## No Practical Alternatives Authorization Certificate

### **AUTHORIZATION of Jordan Lake Water Supply Watershed Riparian Buffer Protection Rules (15A NCAC 2B .0267) and Chatham County Watershed Protection Buffer Rules Section 304(J) Authorization Certificate**

Project Name: Firefly Overlook  
Project Number: WP-23-199

## RIPARIAN BUFFER AUTHORIZATION REVIEW LETTER

# FIREFLY OVERLOOK STREAM IMPACT EXHIBIT

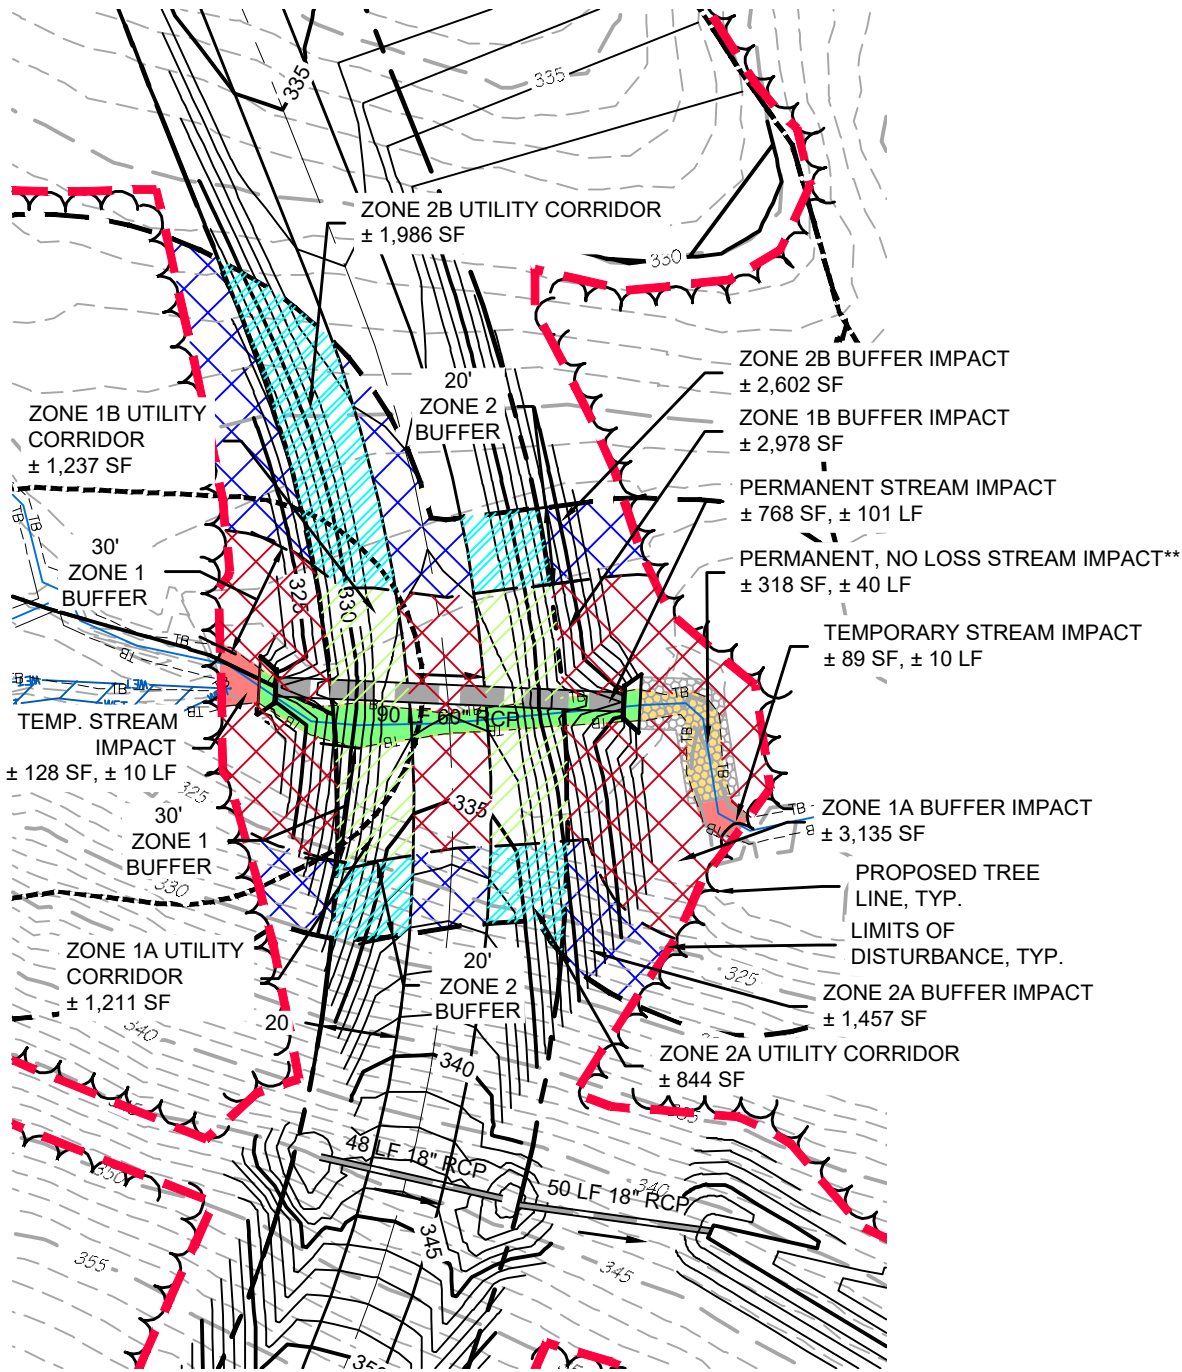
5. Add callouts to impact map that locates 30' Zone 1 Buffer and 20' Zone 2 Buffer on southern portion of impact map.
6. Any hatching that is not called out on impact map should either be removed or called out(darker green hatching).

7. Please provide utility impact amounts as well as installation routes, corridors, and profile views. Utilities include water, sewer, storm sewer, electric, fiber, etc. that are anticipated with the development.
8. Include total face width of impacts on callouts depicting Zone 1 and Zone 2 buffer impacts on both sides of stream. Provide table on impact map summarizing the face width(same as table on overall exhibit map)
9. Zone 1 impact is called out as 7,700 sqft on one side of stream. While that may be the total impact on both sides of stream, it needs to be labeled as such. Provide Zone 1 buffer impact on southern portion of impact map. The call out will need to equal the total impacts for Zone 1 provided.
10. Please clarify the culvert cross sections on Stream Impact Profile.

3. Please see buffer impact narrative.
4. Please see buffer impact sheets
5. Please see buffer impact sheets
6. Please see buffer impact sheets
7. Please see buffer impact sheets. Utility Corridor is dedicated for future use on plans.

8. Please see buffer impact sheets
9. Please see buffer impact sheets
10. Please see buffer impact sheets
11. Please see erosion and sediment control plans

# FIREFLY OVERLOOK STREAM IMPACT PROFILE

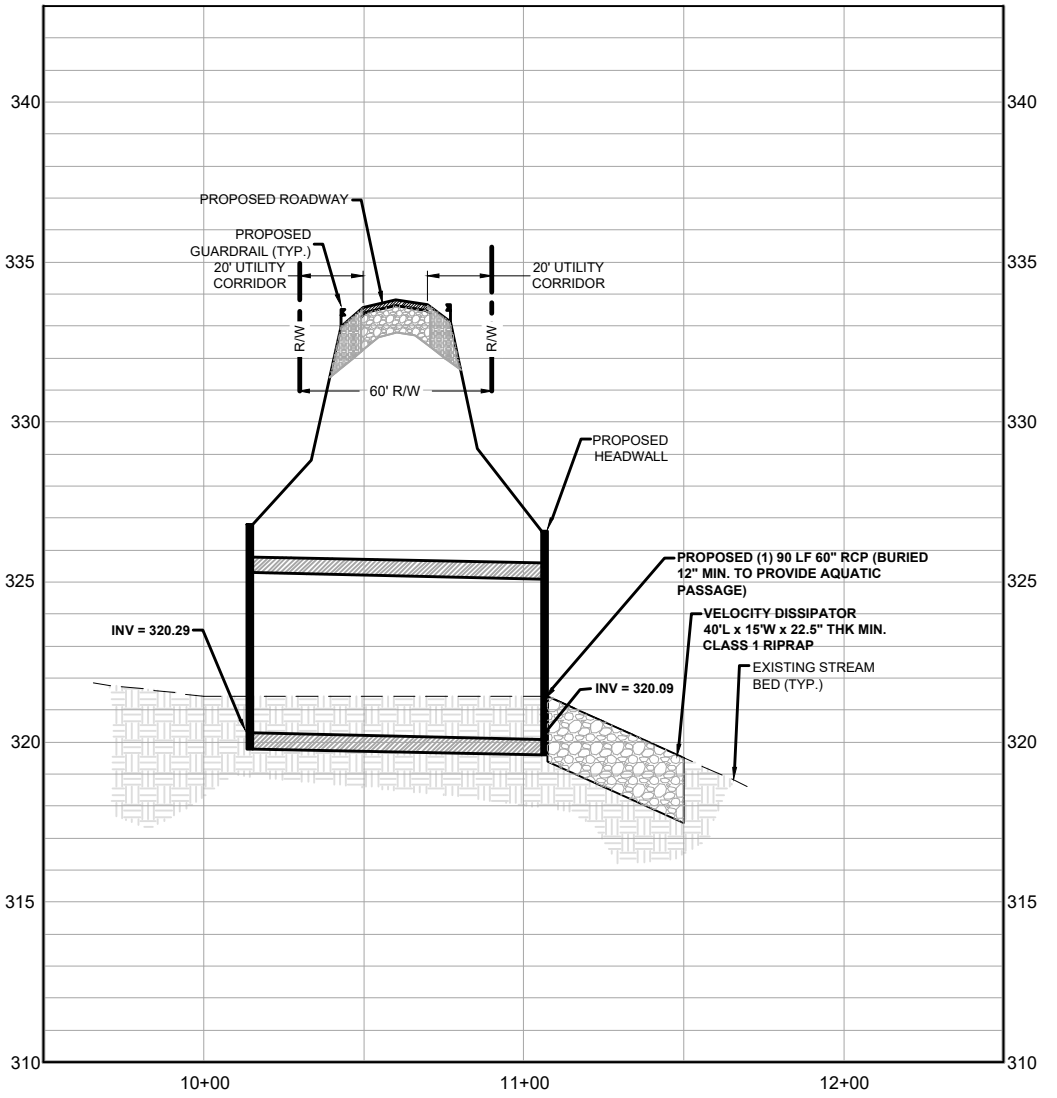
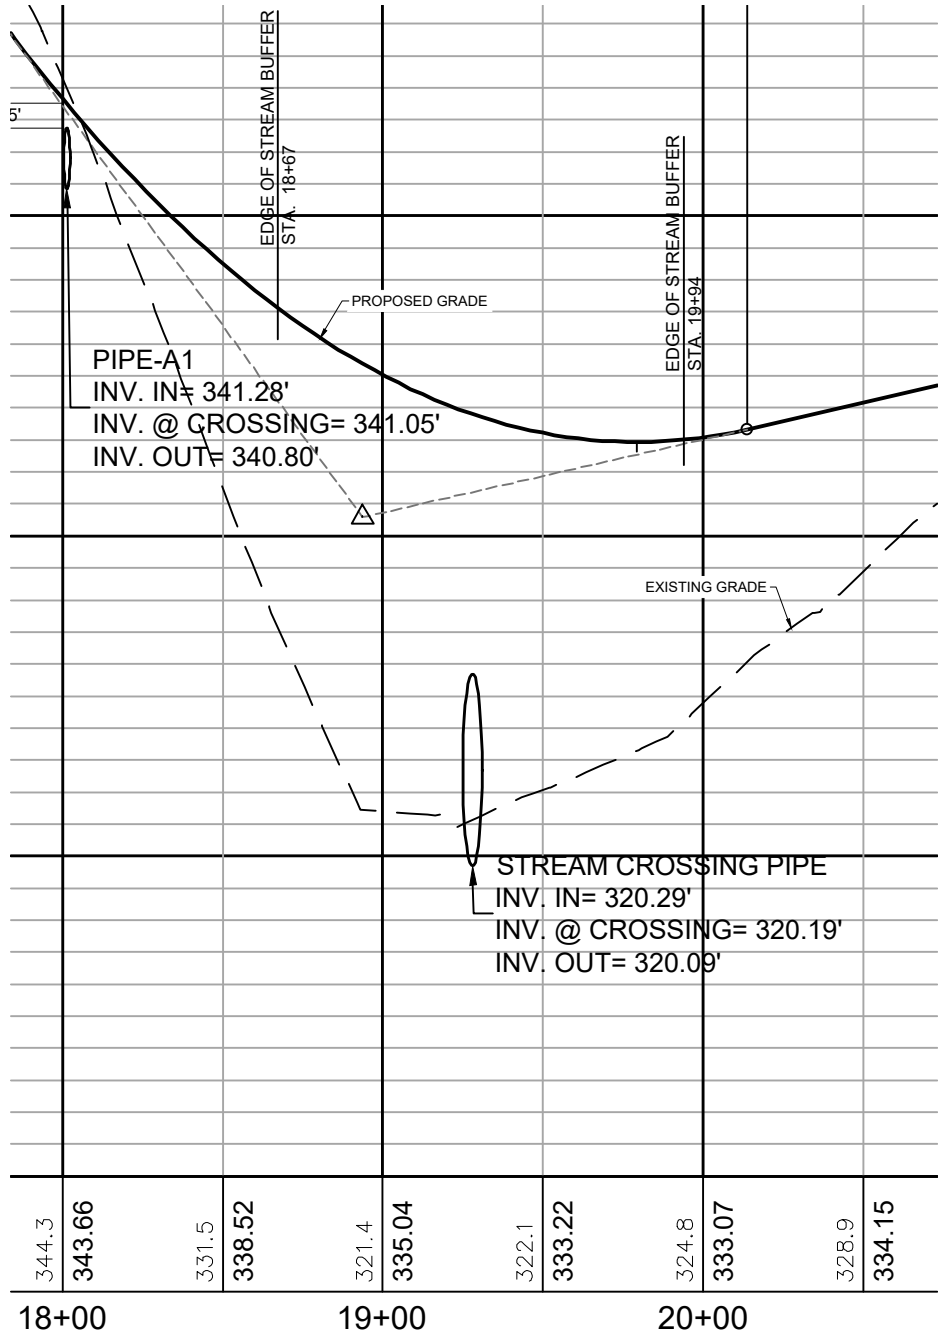
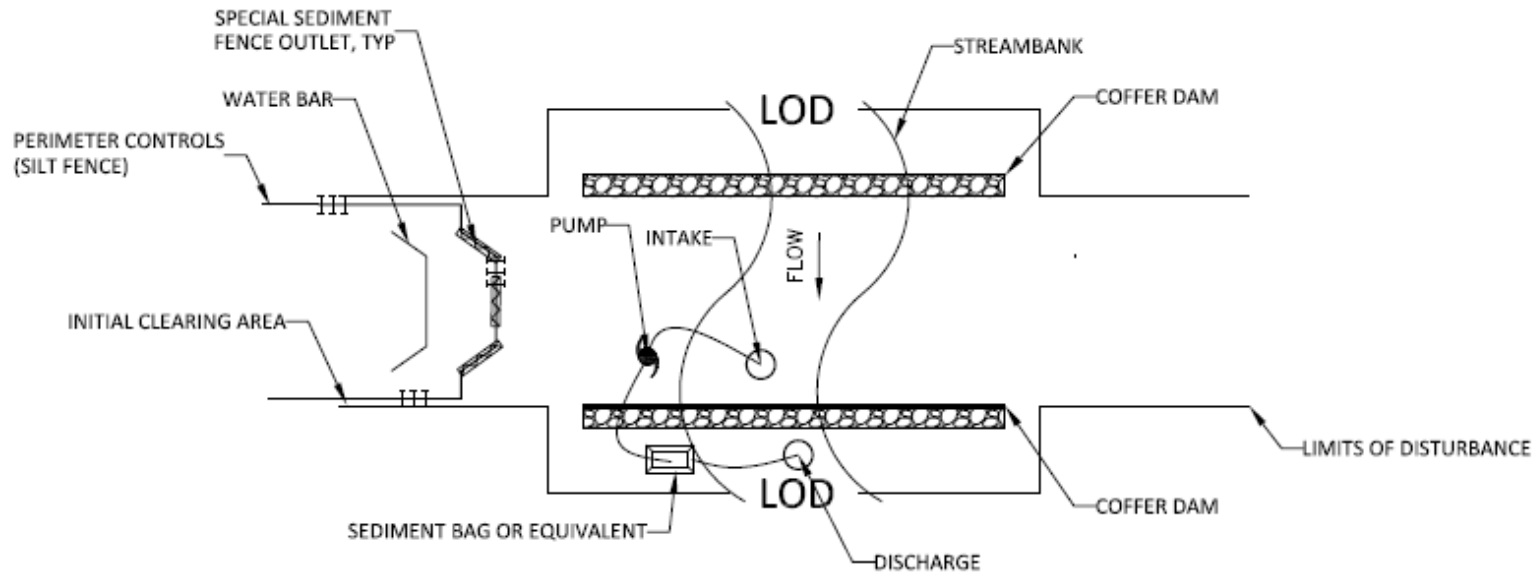
2. Update impact table on plan set to match Impact Summary Table.
3. Please clarify the culvert cross sections on Stream Impact Profile.

1. Please see attached completed project summary impact table
2. Please see attached updated buffer impact map
3. The culvert cross sections will be provided separately by the CE group
4. The Soil Erosion and Sediment Control Plans will be provided separately by the CE group
